Ibrahim Knit Garments Pvt. Ltd. Extension-1

16th February 2021

Building Information

1. Building-4 (G+5)
2. Building-5 (Proposed G+5) (Completed G+2)

Floor layout plan & blow up of toilet zone area.

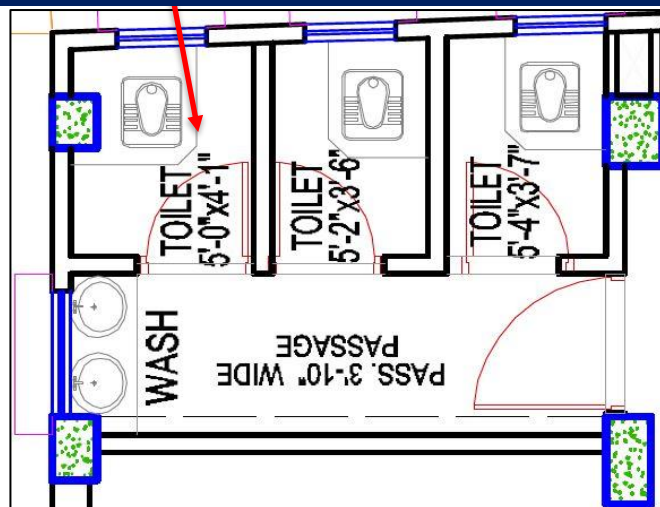
Floor build up found 100 mm

Floor build up and wall height not shown in as-built drawing

In as-built architectural drawing, the height of the toilet partition wall and floor build up were not shown. However, the height of the partition wall was found 1.98 m and floor build up was found 100 mm.

Factory engineer is required to survey the whole structure and update the as-built drawing. Also, Factory engineer to update the design document including in compliance with section 1.9.1 as per BNBC 2006.

Water ponding on roof slab

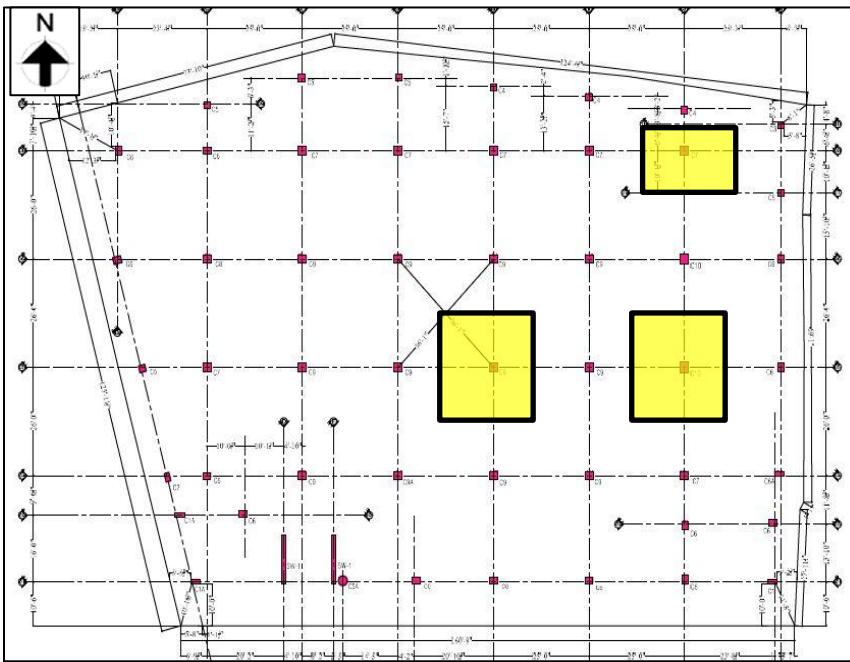
Water ponding was found on roof slab due to improper slope. Any cracks or damage on the roof surface will allow water to seep into the concrete slab beneath the finishes and cause long term soaking of the slab and corrosion of the rebar. Factory is required to provide necessary slope and improve drainage system to prevent water ponding.

Column Layout Plan

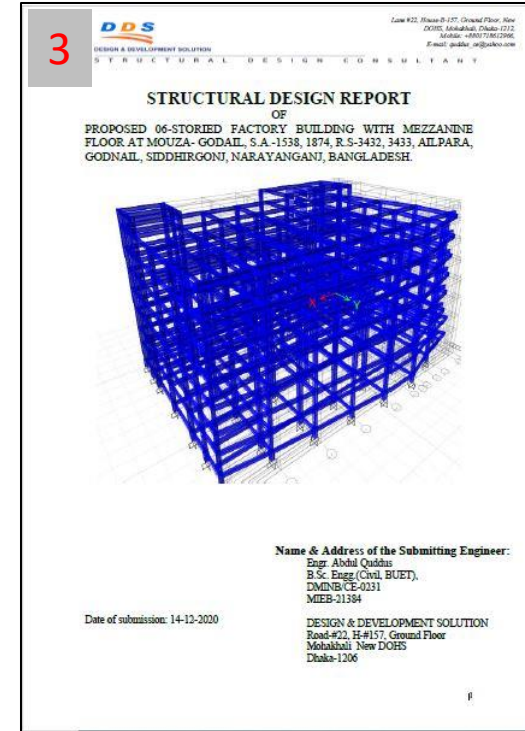
Column to be stressed above normal design limit considering possible vertical extension

Cursory calculation indicates that the marked columns are stressed above normal design limit considering prepared live load plan (5 KPa for typical floor and 1.5 KPa for roof) and minimum concrete strength based on aggregate type for the 6 storied building. Factory engineer is required to carry out a Detail Engineering Assessment (DEA) in compliance with section 1.9.1 BNBC 2006 prior to any vertical extension.

1. Building is currently three storied 2. Extended re-bar at roof for vertical extension 3. Design report prepared for 6 storied structure.

This building is permitted for 6 storied (G+5) storied from local authority. Currently, the building is three storied (G+2). Design documents of the structure has been prepared considering 6 storied building. Also, extended portion of column rebar was found at roof level which indicates the possibility of vertical extension.

Pile Layout plan

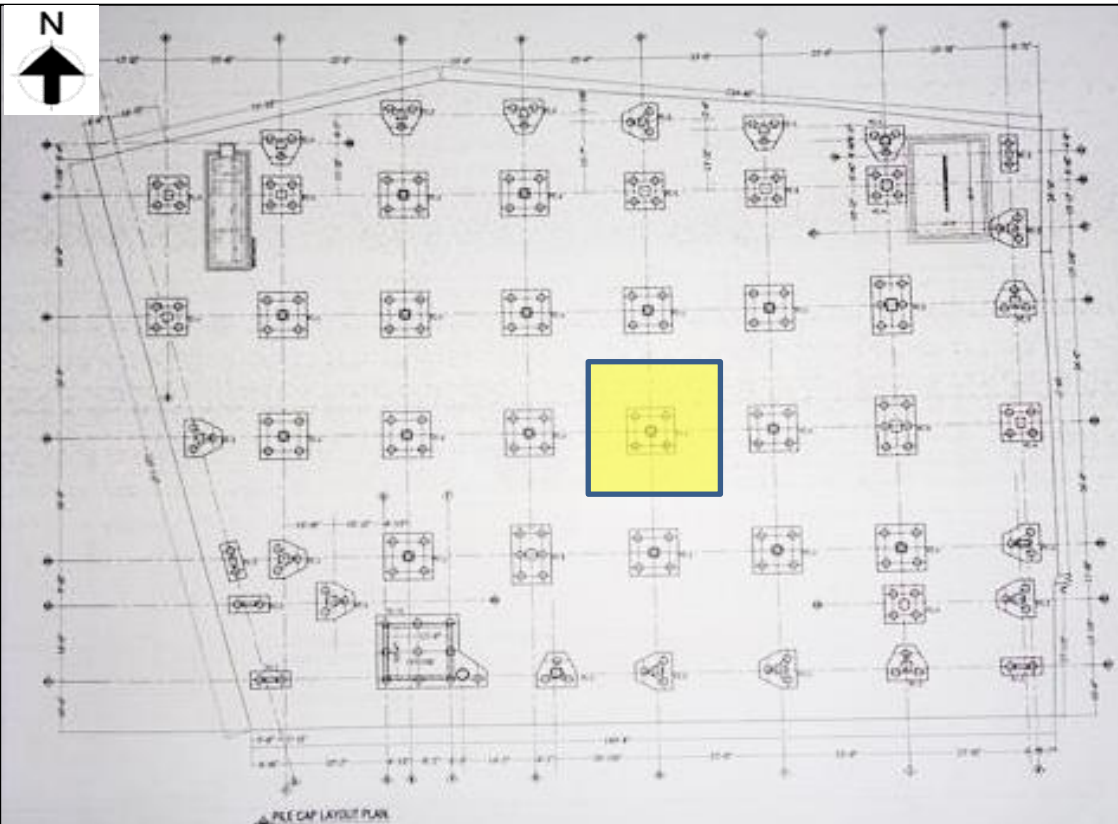
Foundation to be stressed above normal design limit considering possible vertical extension

Building is currently three storied

Cursory calculation indicates that the marked foundation is stressed above normal design limit considering prepared live load plan (5 KPa for typical floor and 1.5 KPa for roof).
Factory engineer is required to carry out a Detail Engineering Assessment (DEA) complying with BNBC prior to any vertical extension.

Column layout

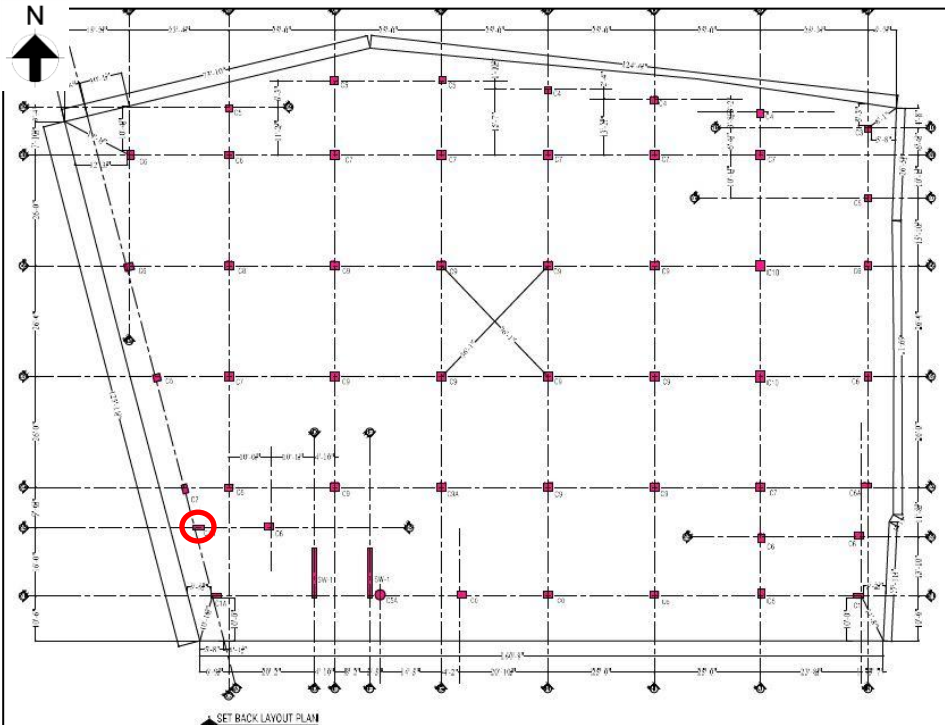
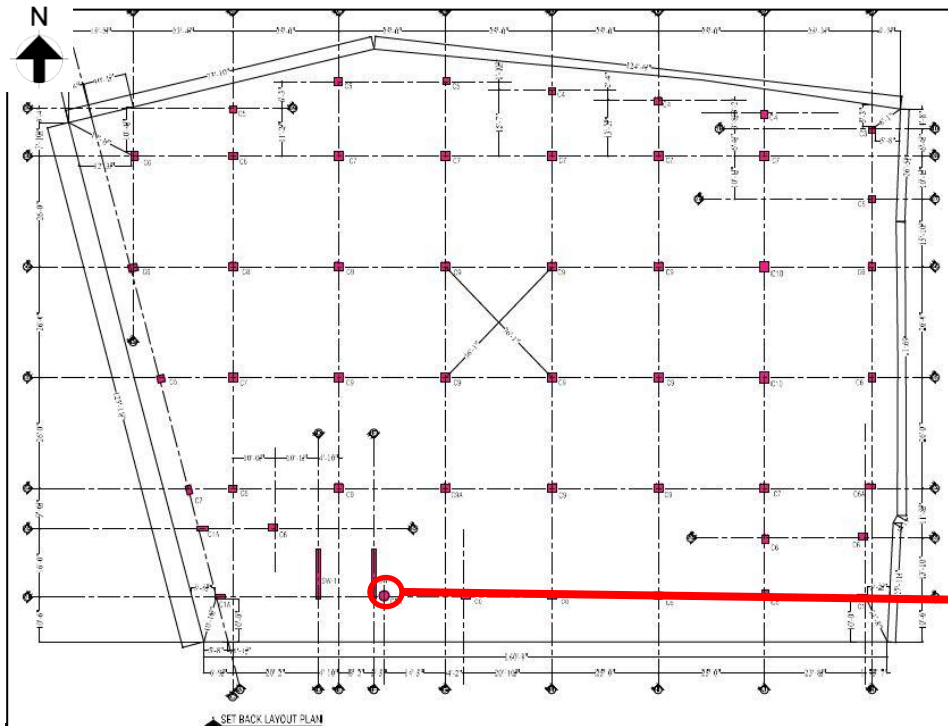
Dimension of the highlighted column (C-1A) was found 350mmX625mm instead of 300mmX750mm. Factory engineer is required to survey the whole structure and update the as-built drawing in compliance with the section 1.9.1.2 (Part-6; BNBC 2006).

Dimension shown in schedule-300mmX750mm

Dimension found -350mmX625mm
